**BELL BEND NUCLEAR POWER PLANT
PARTIAL RESPONSE TO RAI No. 90 AND
REQUEST FOR EXTENSION
BNP-2010-089 Docket No. 52-039**

Response to NRC Request for Additional Information No. 90,
Questions 03.08.05-1, 03.08.05-2, 03.08.05-3, 03.08.05-6, 03.08.05-10, 03.08.05-11
Bell Bend Nuclear Power Plant

FIGURE A
COMPARISON OF THE FIRS ALONG THE HORIZONTAL DIRECTION

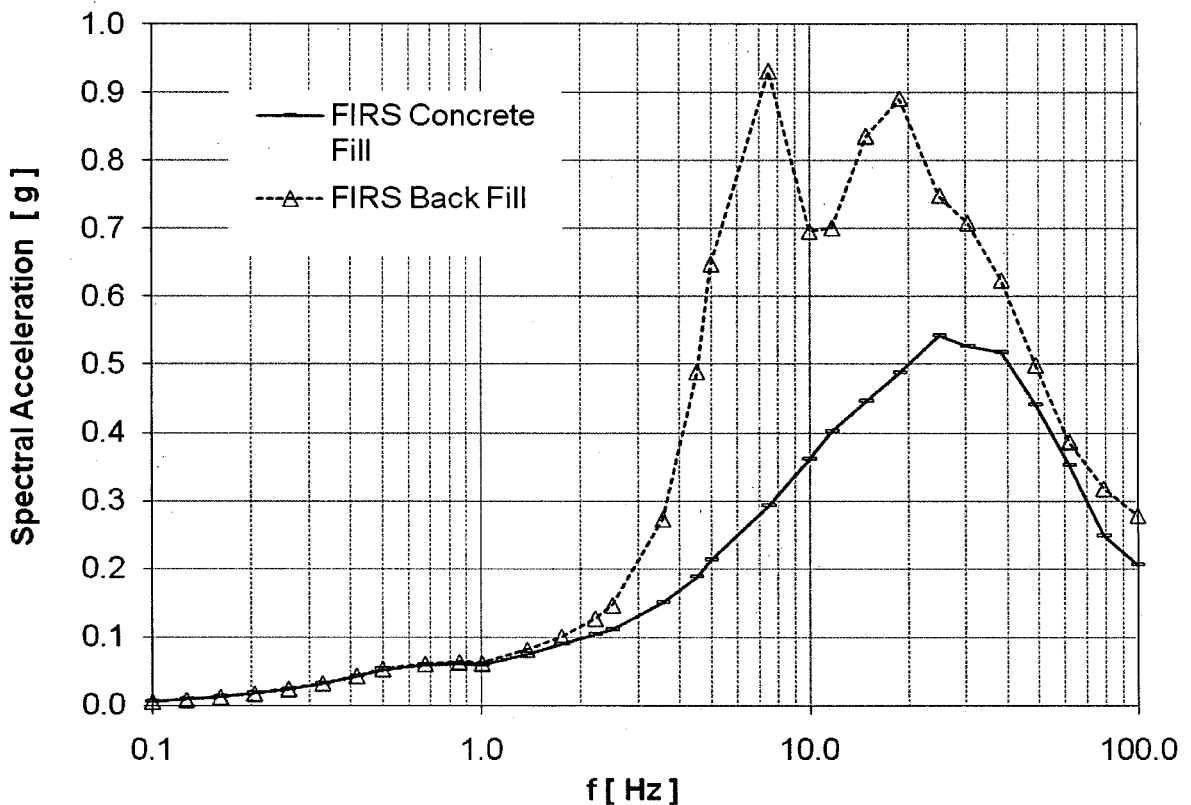
- (1) (a) Where are the dynamic spectrum analysis for the ESWEM Pumphouse and the ICEC SASSI analysis presented?
(b) Does the input for the dynamic spectrum analysis include the effect of SSI (soil structure interaction)?
(c) What is the input motion used for the ICEC SASSI analysis?
(d) Describe the structural model used in ICEC SASSI analysis.
- (2) Explain the meaning of the sentence in Step 1 more clearly, and include a discussion of the use of the two computer codes and two models and how they interrelate.
- (3) (a) Provide a description for "static seismic loads of SSE" in Step "2".
(b) How were the "static seismic loads of SSE" in Step "2" computed and applied to the model?
- (4) In the GT-STRUDL static analysis, what are the boundary conditions assumed for the model?

2. The base mat of the ESWEMS Pumphouse was designed using a Response Spectrum Method. The input FIRS used in the design were for engineered back fill rather than concrete fill, which has a lower input motion as shown in Figure A, below:

For the design of the structural components, such as walls, floors, base mat, and shear keys of the ESWEMS Pumphouse, the axial, shear forces, and moments were derived from element reactions. They are tabulated in FSAR Tables 3.E-3 through 3.E-6. Given the inherent conservatism in the input FIRS and use of rigid supports without SSI effects, the detail design of the structure can be more refined using a three step analytical process as described in FSAR Section 3.8.5.4.6. Step 1 involved a Time History Analysis by ICEC SASSI (V. 1.3) to determine in-structure seismic response spectra (ISRS), using a GT-STRUDL finite element model. This step is essential to provide refined ISRS inputs for subsequent response spectrum analysis. In
